Duke Energy Ohio
Case No. 19-1471-EL-BLN
STAFF Second Set of Data Requests B
Date Received: Wednesday, November 6, 2019

STAFF-DR-02-001 B

REFERENCE:
USGS 7.5' TOPOGRAPHIC
QUADRANGLE: CINCINNATI EAST, OHIO.
OBTAINED VIA ESRI USA TOPO,
NATIONAL GEOGRAPHIC TOPO,
AND USGS, ACCESSED 10/2018

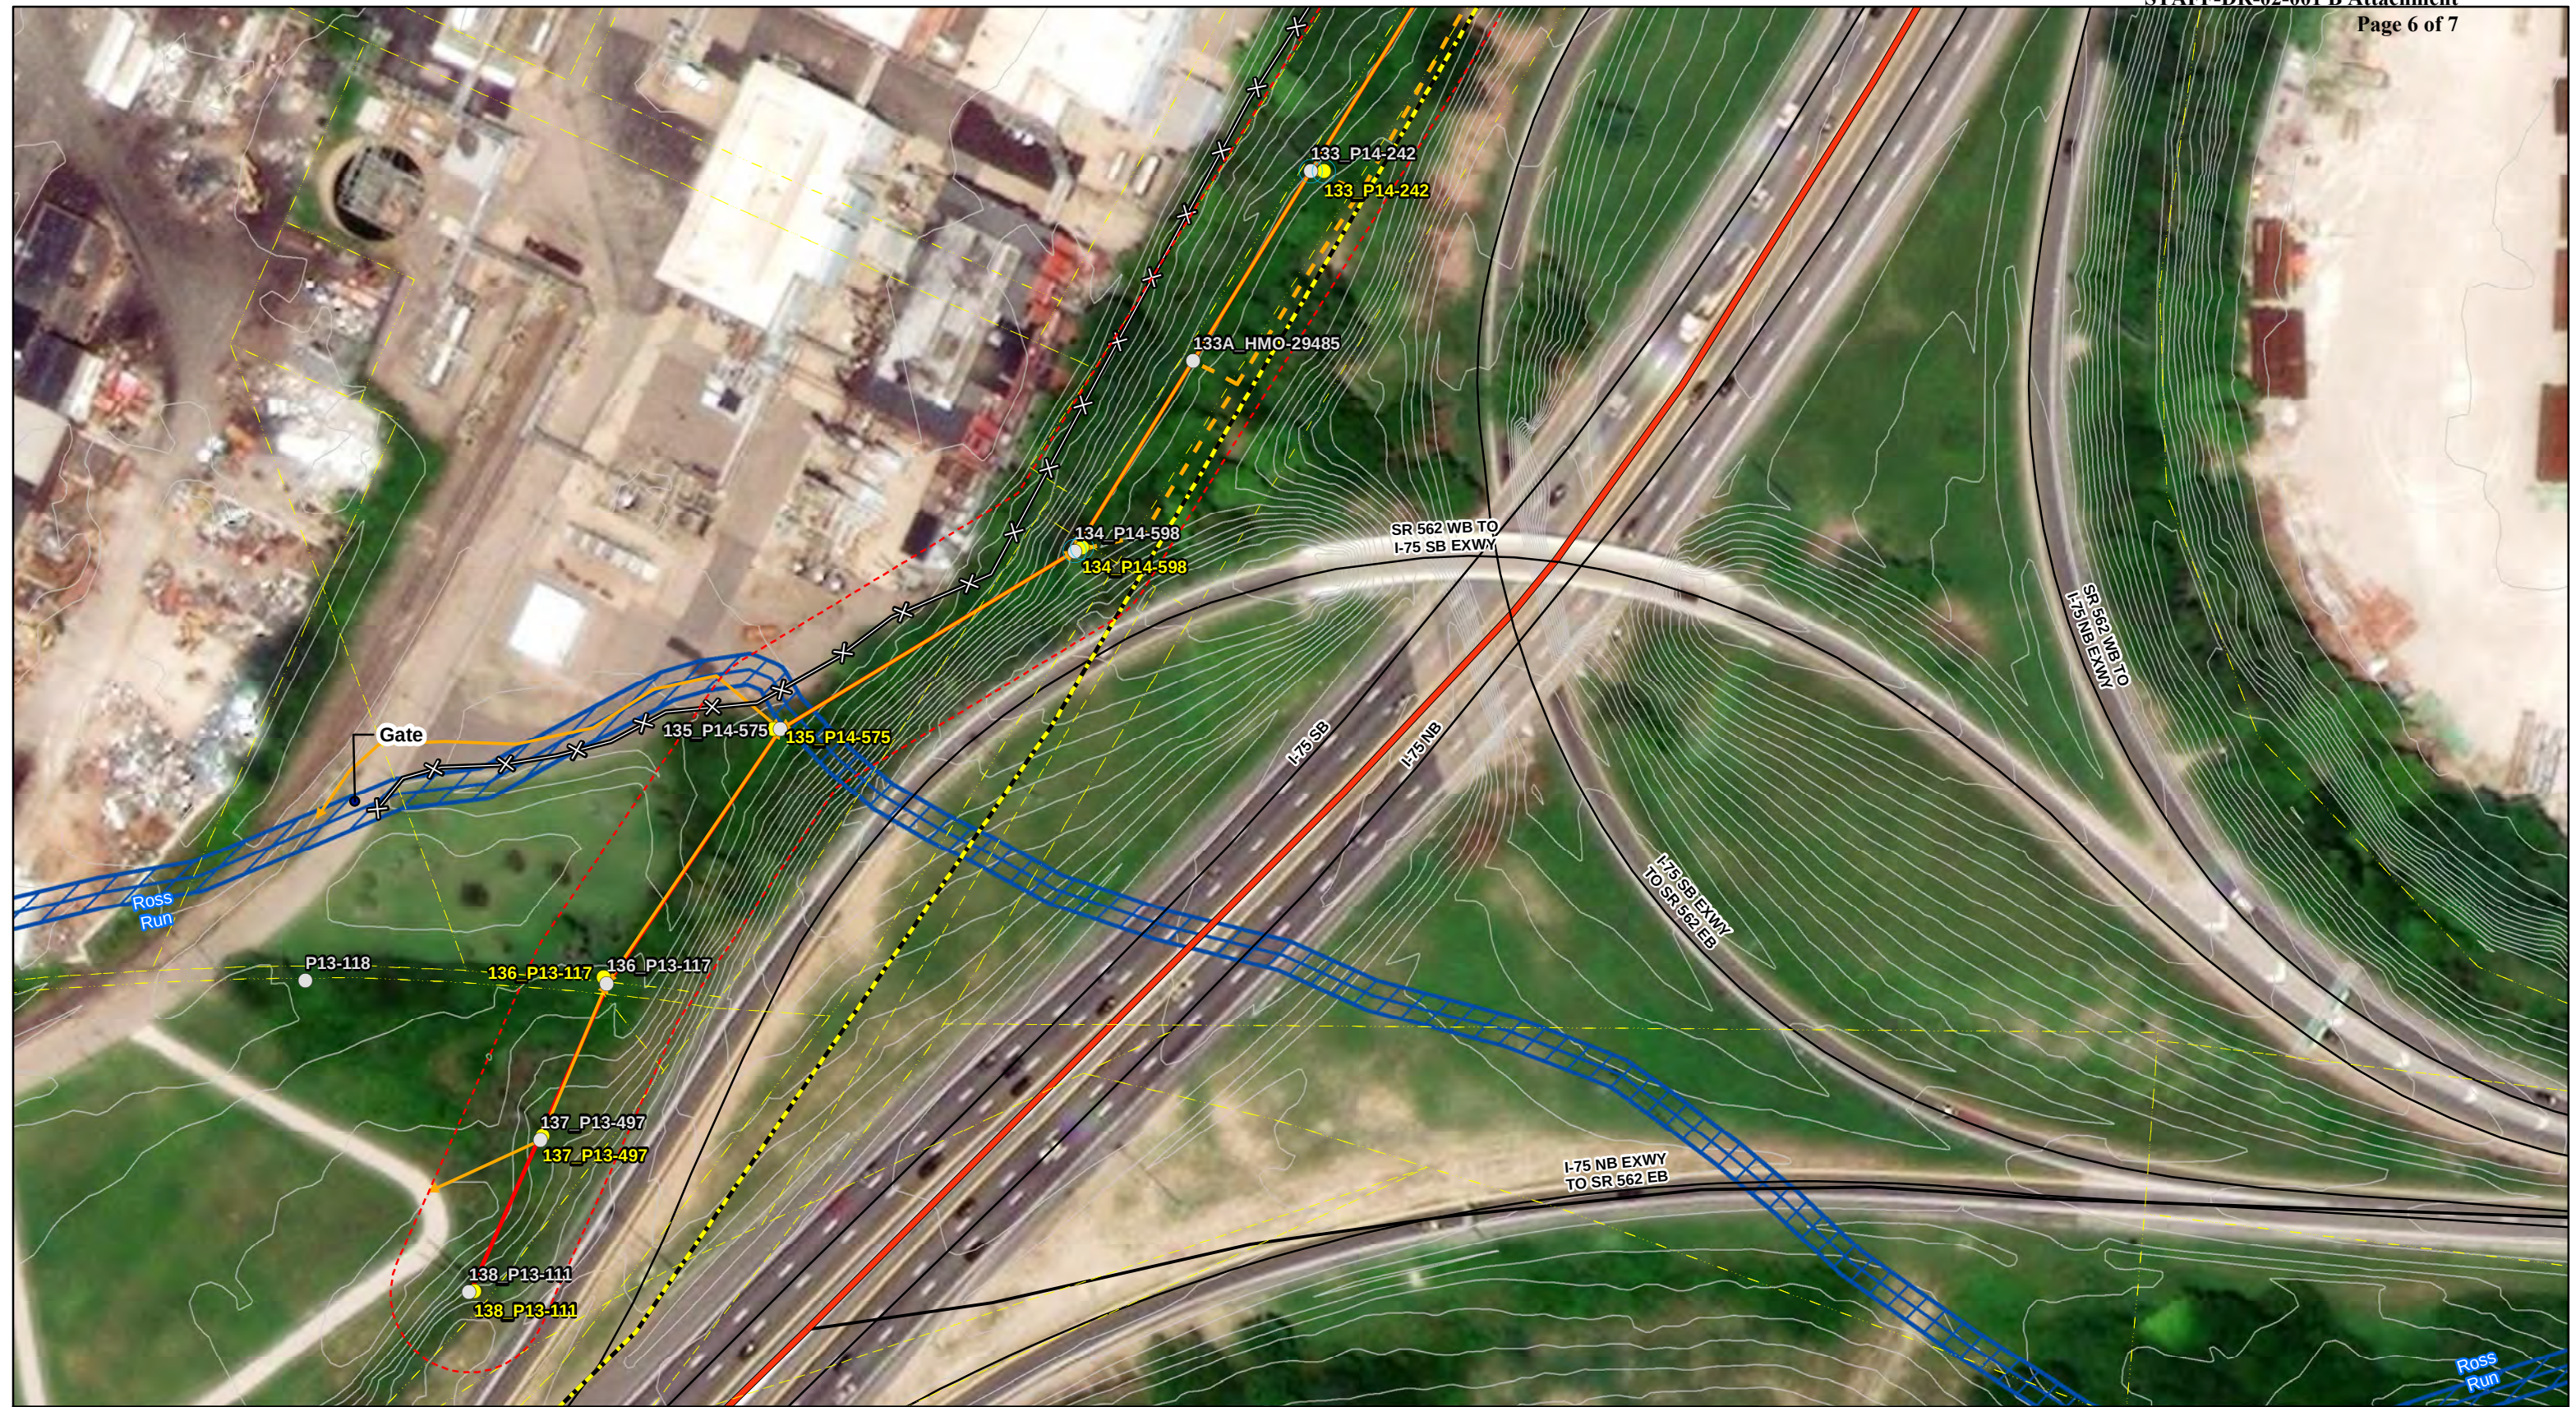
Staff is looking for clarification on the structures ODOT is requiring Duke to relocate, and the distances between the existing and new structure locations.

1. Can you provide to Staff the number of structures ODOT is requiring relocation of?
 - a. The structure numbers and a corresponding map for Staff to review of those structures, and the distances between the existing and new structures for Staff to review?

The following is a list of the reasons for changing the various poles involved in the project, impacted by : uplift and age

- A. These poles are required to move as far west as possible due to SR562 on ramp conflicts:
 - 684-P14-242
 - 684-P14-244
 - 684-P14-247
 - 684-P14-249
 - 684-P14-250
 - 684-P14-252
 - 684-P14-254
 - 684-P14-598
- B. These poles are required to be raised in height to accommodate anticipated future railroad crossing construction and operations:
 - 684-P14-707
 - 684-P14-708
 - 684-P14-709
 - 684-P14-168
- C. These poles are required to be moved West in addition to be raised vertically for construction clearances. ODOT plans to reconstruct the bridge structure.
 - 684-P14-275
 - 684-P14-705

D. These poles are in direct conflict with the proposed sound wall for I75:

- 684-P15-483
- 684-P15-647
- 684-P15-655
- 684-P15-656
- 684-P15-657

With regard to the remaining poles, the increased pole heights associated with the changes listed above require other nearby poles to also be replaced with taller poles. This is the basis for their inclusion in this project.

The following table sets forth, for each pole, whether it is a new pole or, if not, how far it will be from existing poles:

POLE NUMBER	DISTANCE FROM OLD POLE (FT)
103_P15-559	3
P13-560	3
P13-738	3
104_P15-490	3
105_P15-659	2
P15-661	3
106_P15-657	4
106A_HMO-29466	NEW POLE
107_P15-656	3
108_P15-655	4
109_P15-647	4
110_P15-483	3
110A_HMO-29467	NEW POLE
111_P15-352	3
P15-354	3
112_P15-369	31
112A_HMO-29468	NEW POLE
113_P15-368	52
114_P15-367	73
115_P15-365	39
116_P14-424	32
HMO-29469	NEW POLE
116A_HMO-29470	NEW POLE
117_P14-275	12
117A_HMO-29471	NEW POLE
117B_HMO-29472	NEW POLE
118_P14-705	5
119_P14-706	5

120_P14-707	3
121_P14-708	3
122_P14-709	4
123_P14-168	3
124_P14-568	29
125_P14-567	3
126_P14-400	4
127_P14-254	12
128_P14-252	34
129_P14-250	92
129A_HMO-29473	NEW POLE
130_P14-249	39
131_P14-247	94
132_P14-244	21
132A_HMO-29474	NEW POLE
132B_HMO-29475	NEW POLE
133_P14-242	9
133A_HMO-29485	NEW POLE
134_P14-598	4
135_P14-575	3
136_P13-117	3
137_P13-497	6
138_P13-111	5

Attached as Staff-DR-02-001 B Attachment is a map showing existing lines and structures, proposed lines and structures, and the rail crossing, together with an identification of which poles are being replaced at the direct request of ODOT.
